The Graduate Austin

Design Commission

December 11, 2023

Working Group Recommendations 11/8/2023

PS 1: Protect the Pedestrian Where the Building Meets the Street

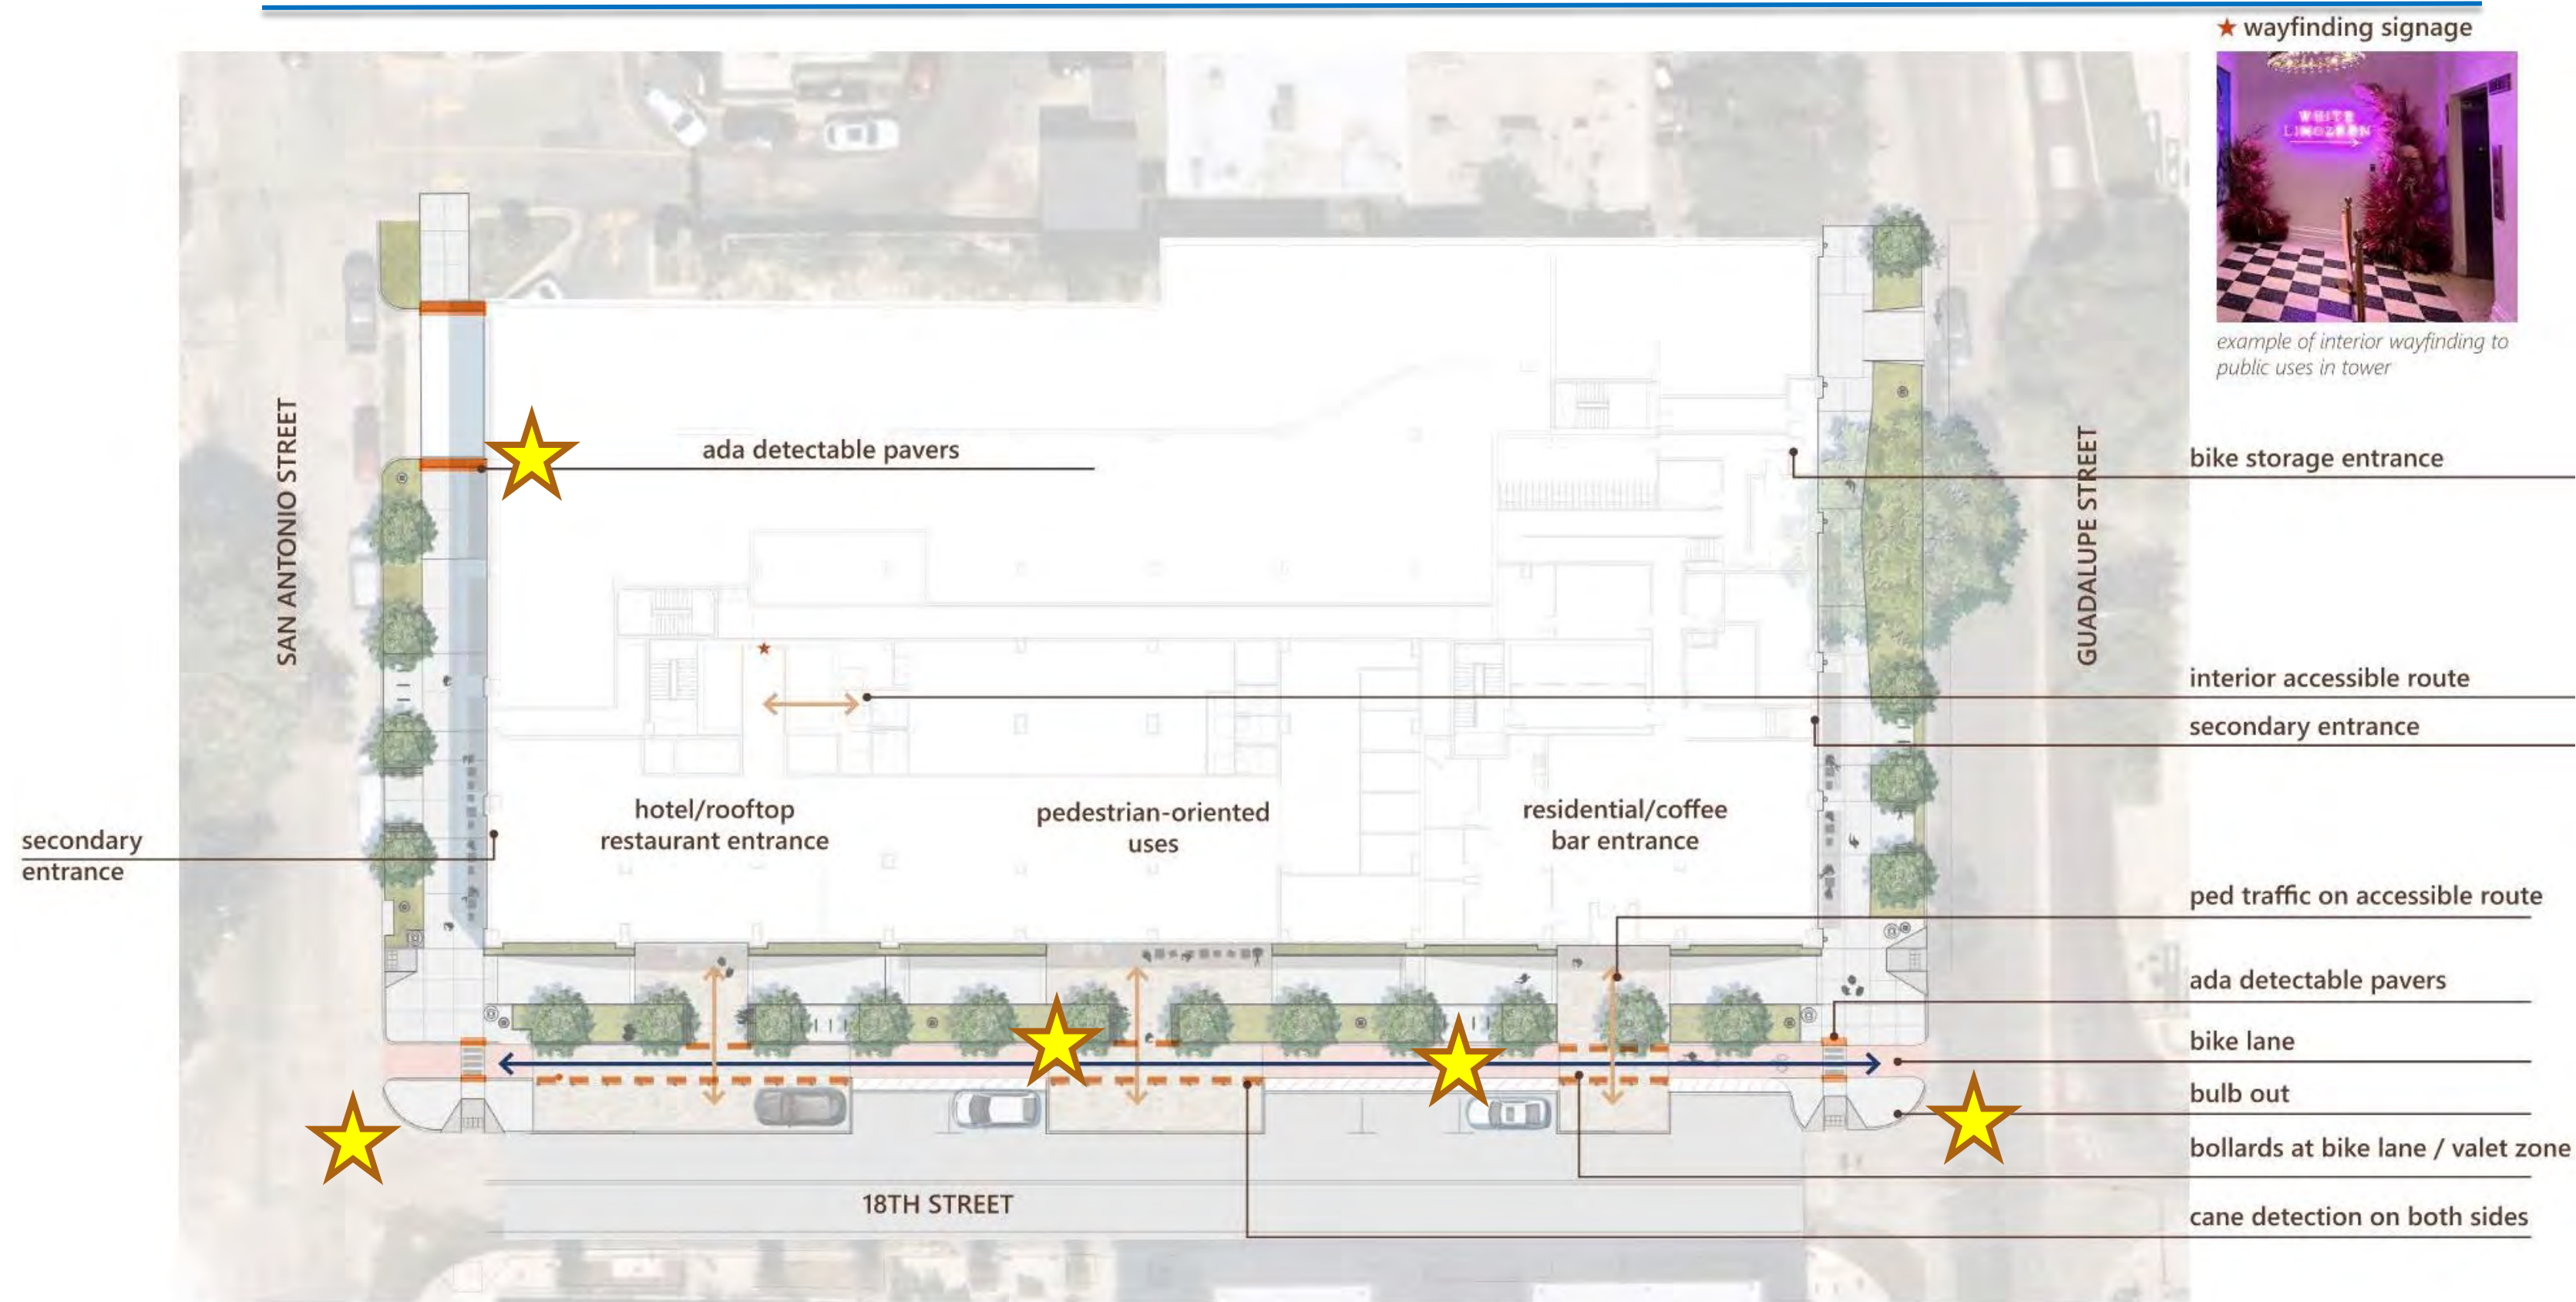
Urban Design Guideline	Working Group Recommendation
PS 1: Protect the Pedestrian Where the Building Meets the Street	Provide more information at both San Antonio and Guadalupe streets for the street plazas, at the parking garage entry and address how pedestrian will be protected walk across driveway.
PS 10: Provide Protection From Cars/Promote Curbside Parking	Protect cyclist at raised curb drop-off by preventing vehicles from encroaching into bike lanes.

view of san antonio street at garage entrance - art by Emily Eisenhart

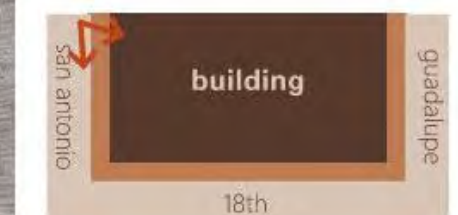
Urban Design Guideline	Working Group Recommendation
PS 12: Provide Generous Street-Level Windows	Generous windows provided however, large portions of windows along San Antonio and Guadalupe are within loading and back of house areas. Applicant is encouraged to provide activated uses behind these large windows.

aerial view from southwest corner of rooftop

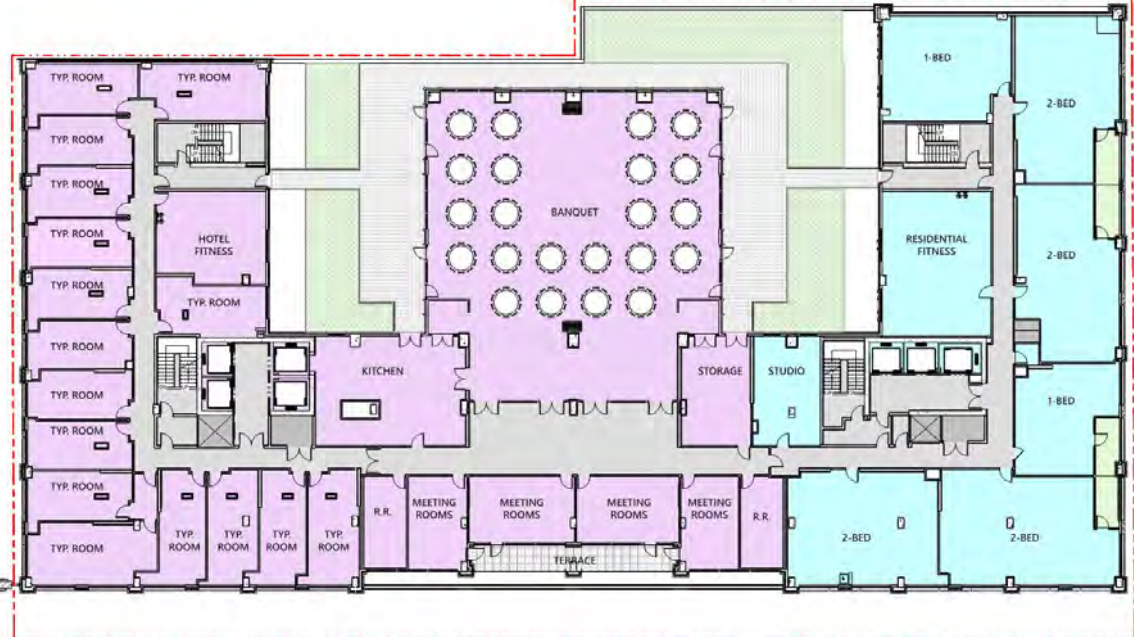
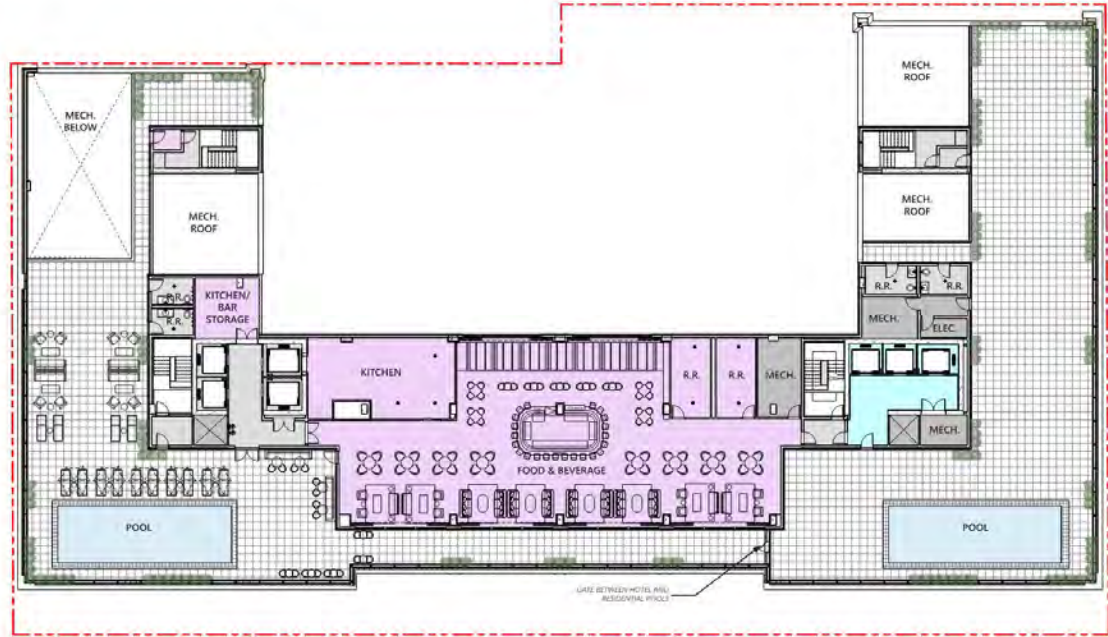
Urban Design Guideline	Working Group Recommendation
PZ 5: Develop Green Roofs	No green roofs proposed for this project.

PZ 7: Determine Plaza Function, Size and Activity

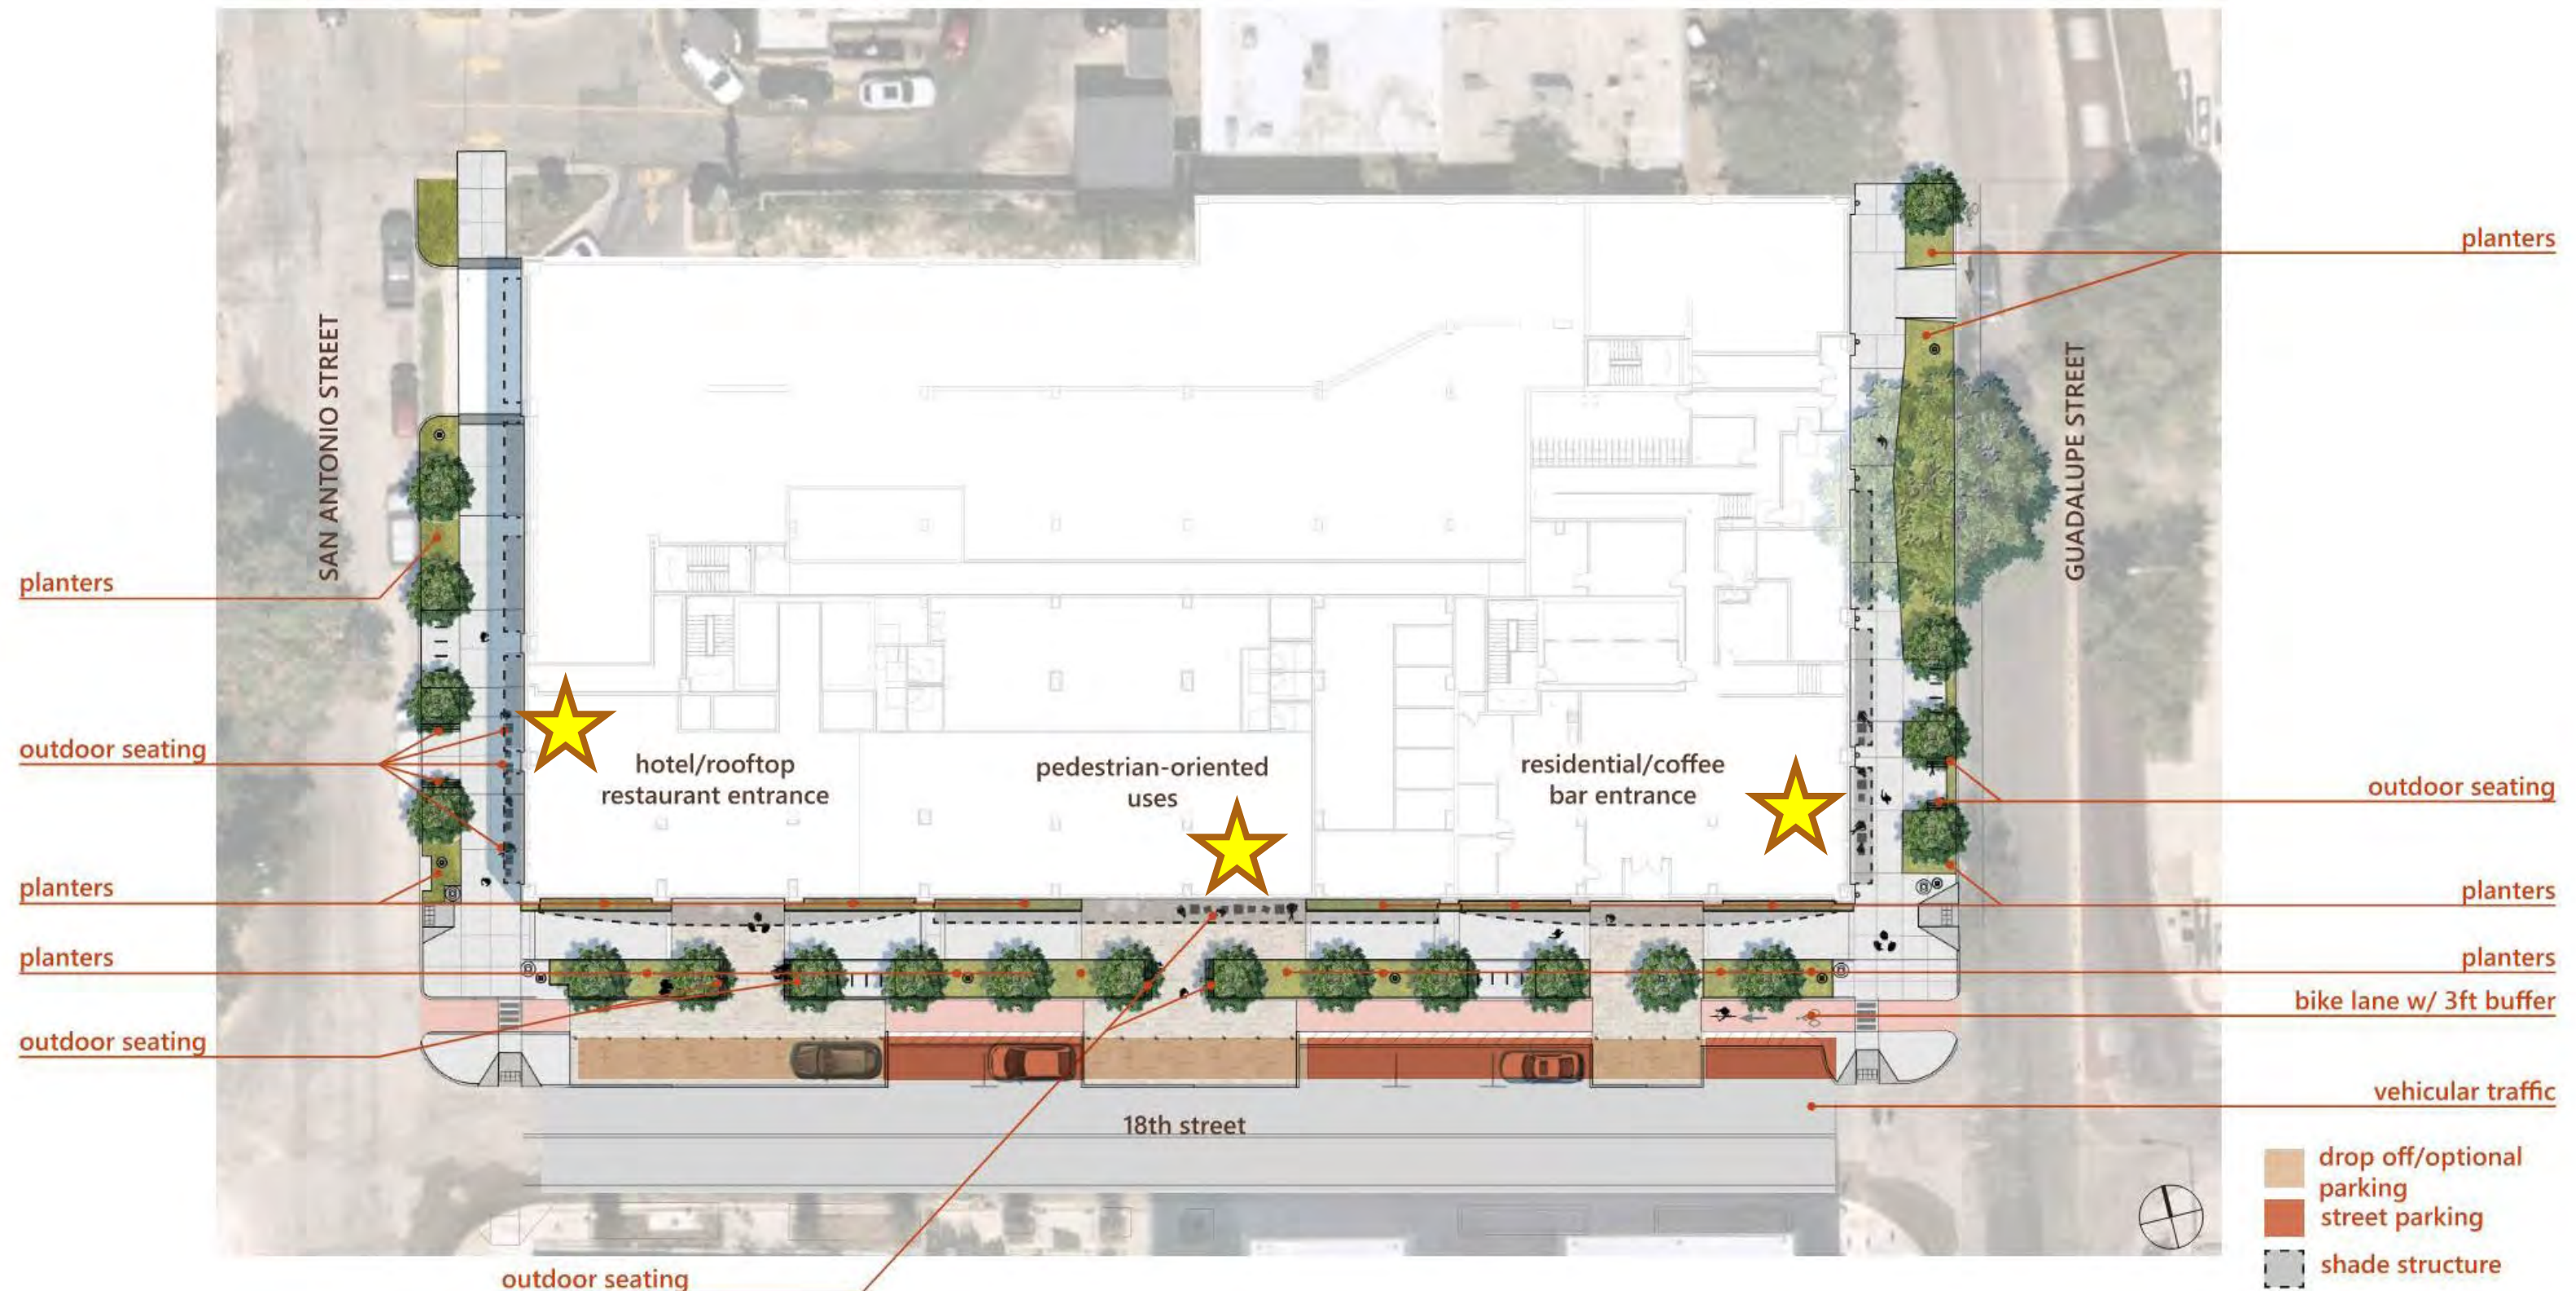
Urban Design Guideline	Working Group Recommendation
PZ 7: Determine Plaza Function, Size and Activity	Street plazas appear to meet great street standards, however no connection to the interior activated uses exists. Tables and chairs do not directly connect or correlate to any interior use.
PZ 10: Provide an Appropriate Amount of Plaza Seating	Refer to the recommendations in the design guidelines to provide for a variety of seating locations which accommodate the needs of various sitters.
PZ 14: Provide Food Service for Plaza Participants	No direct food service or outdoor sitting area directly related to street plaza. Applicant is encouraged to provide more connectivity to first floor activated use.
